### **3.2.2 Injection Flow.**

## **Attachment A-2, Groundwater Modeling Report**

FIGURE A-18: Closure Strategy Decision Tree

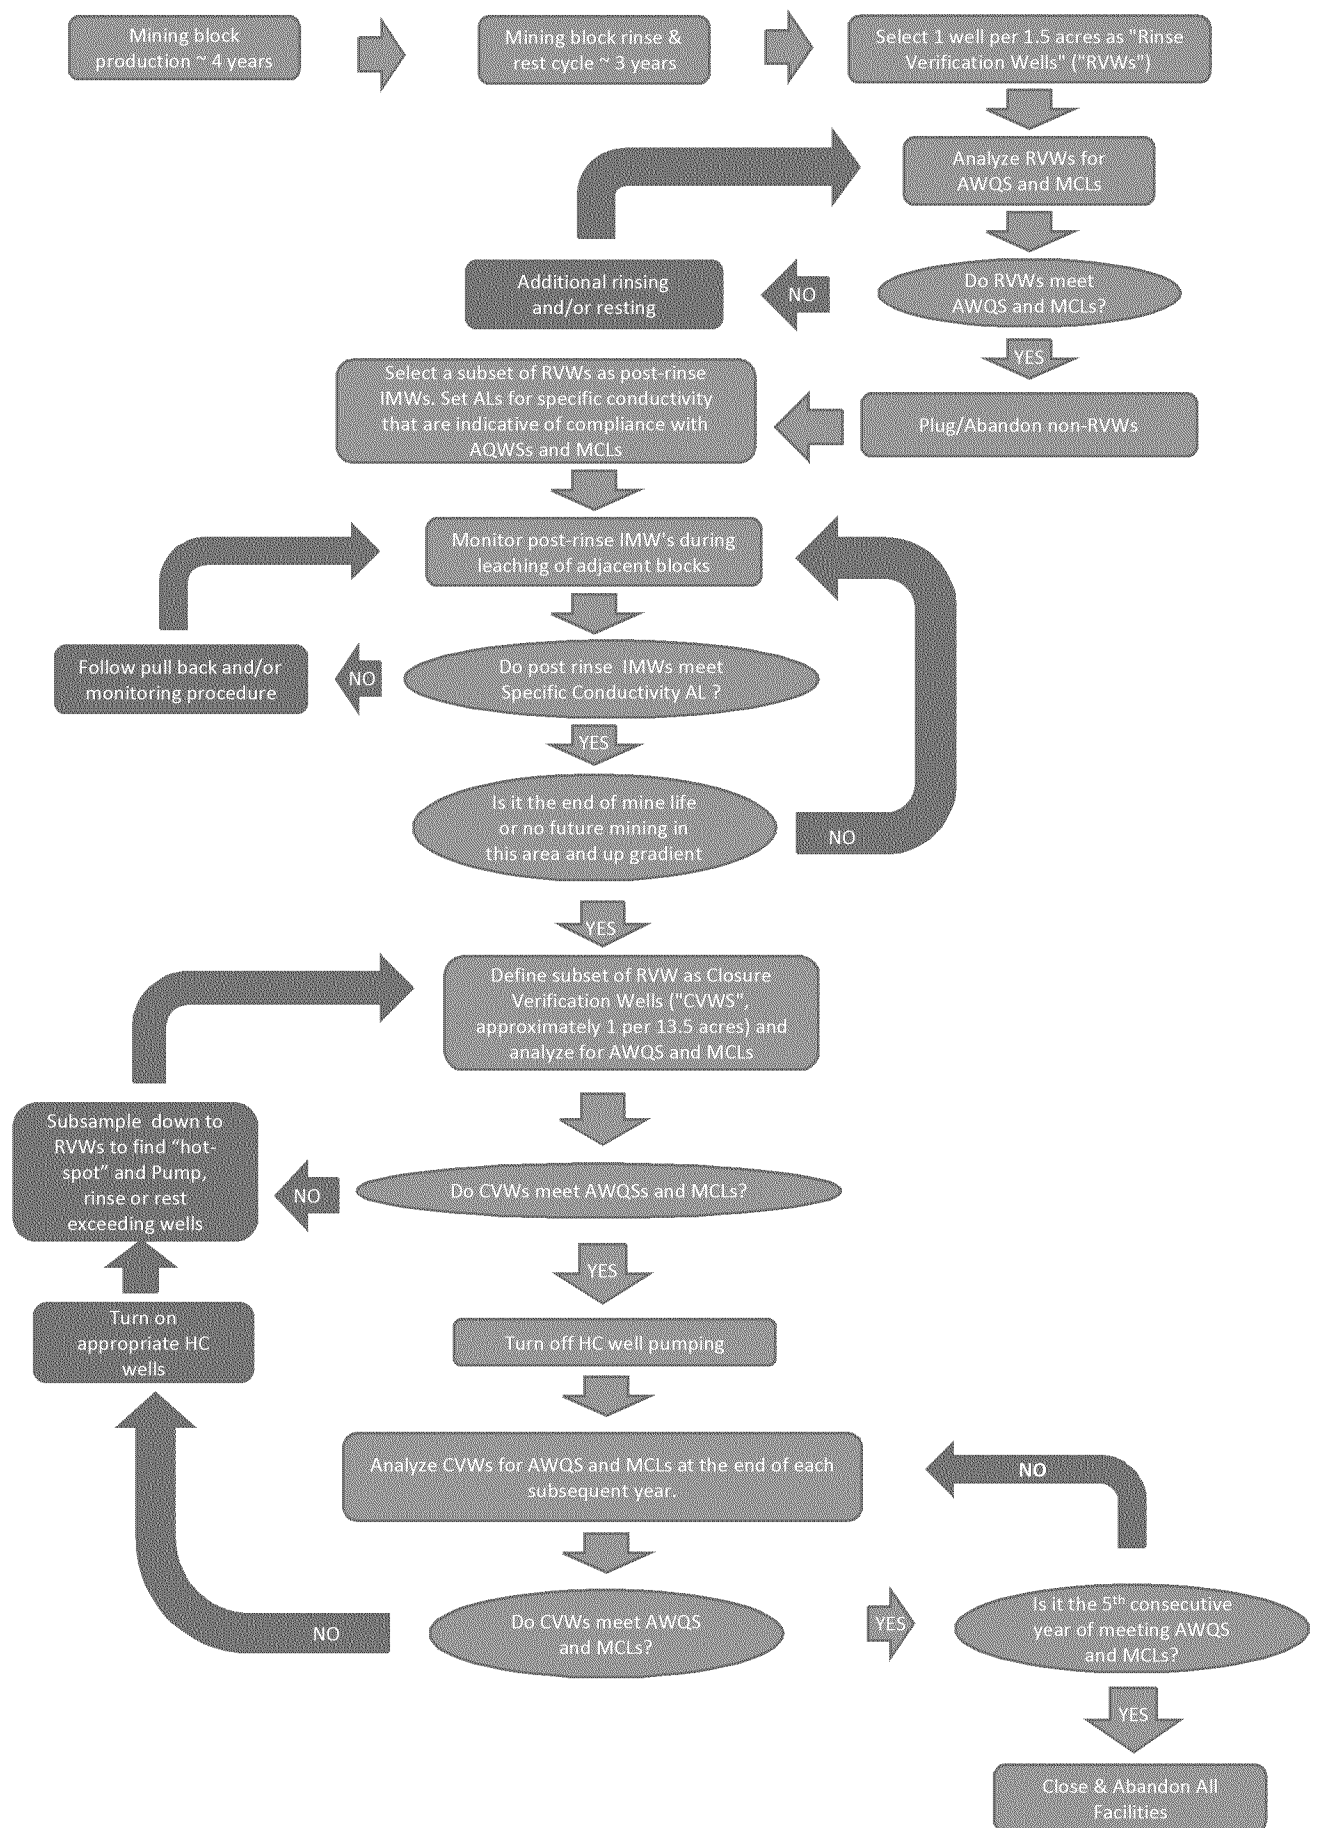
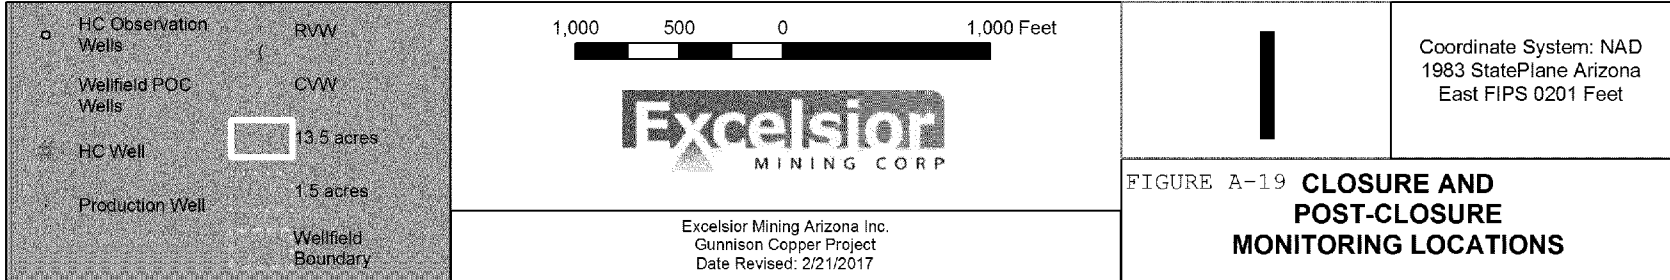
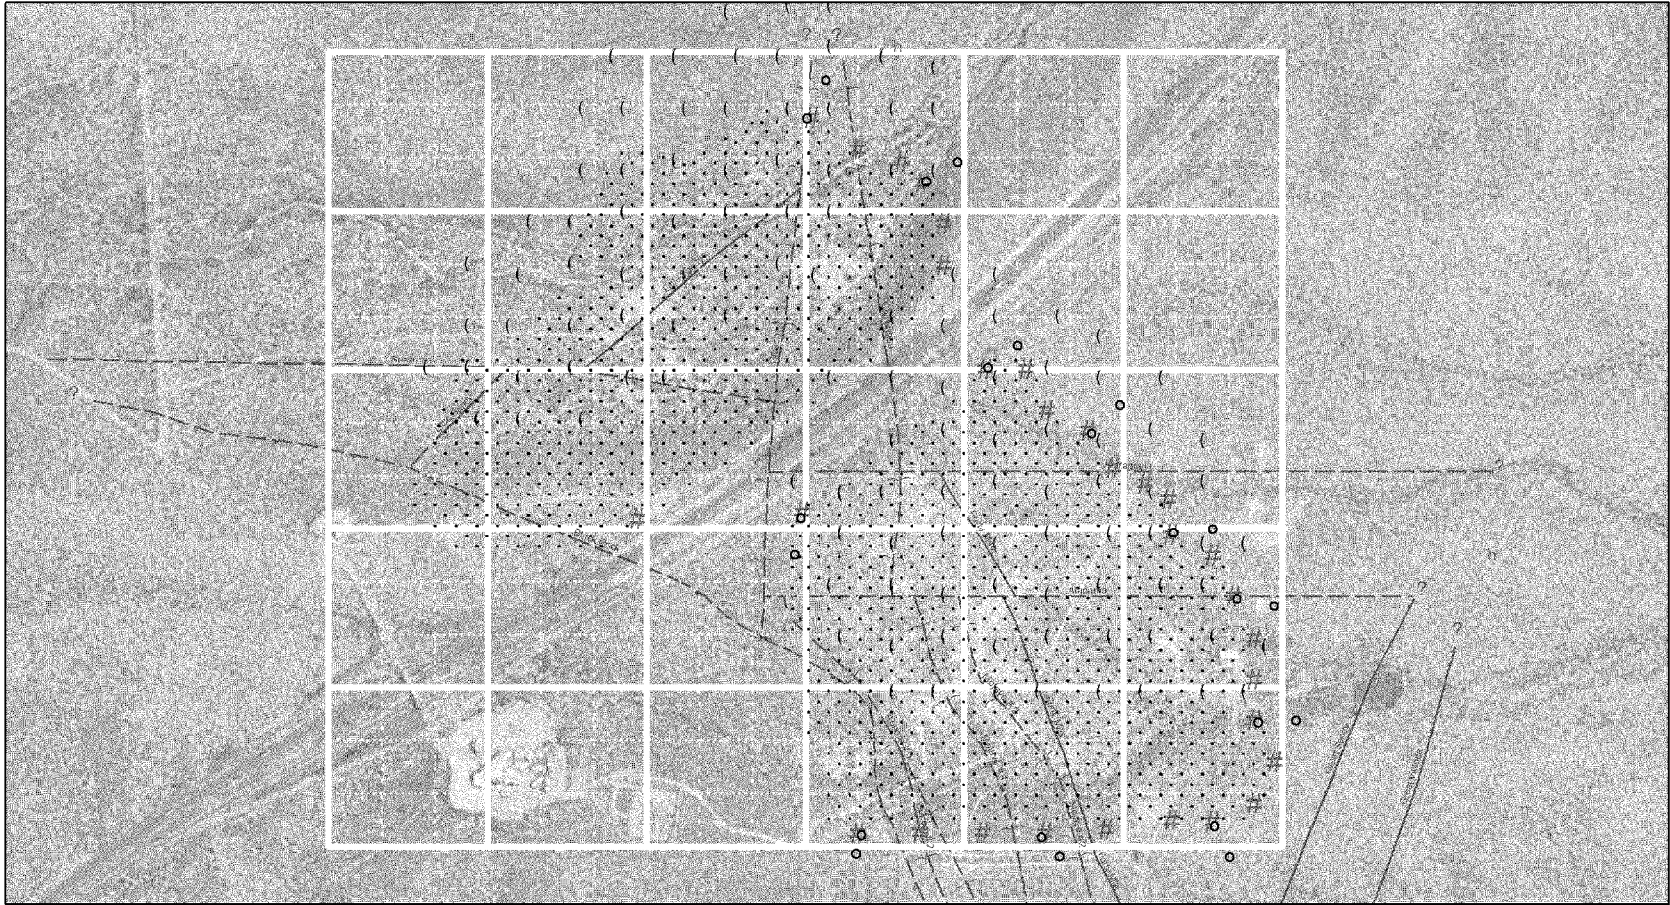
15. (17) POC wells are to be placed at an appropriate distance to detect movement of regulated constituents during the proposed five-year post-closure monitoring period. Permit conditions may require additional POC wells to be placed at the AOR boundary or closer to the wellfield perimeter if recalibration of the groundwater flow model during ISR operations indicates a need for closer spacing of POC wells. Excelsior proposed the retention of 10 percent of the injection and recovery wells for post-rinse monitoring through the life of the mine, as presented in the February 9th PPT presentation. This would include monitoring a subset of retained wells annually for five years to verify no rebound has occurred.

Excelsior should clarify the rationale for the proposed POC well spacing at the eastern AOR boundary in response to our concerns about distance of the POC wells from the wellfield. The closure/post-closure strategy described in the February 9 PPT presentation should be added to the updated permit application. Monitoring frequency will be subject to EPA permit conditions and adjustment for monitoring results during rinsing and post-closure monitoring.

Section 3.2.7 of Attachment A-1 will be revised to include the closure/post-closure strategy as follows:

*A rinsing closure strategy is proposed for the wellfield. After copper recoveries drop below the economic cutoff, ISR in a given production block will be deemed complete and the block will be rinsed using fresh groundwater until applicable water quality standards are met. A flow chart that summarizes the closure strategy is provided as Figure A-18.*

*To get to final closure, the following steps (which are also shown on the flow chart—figure A-18) will be taken:*
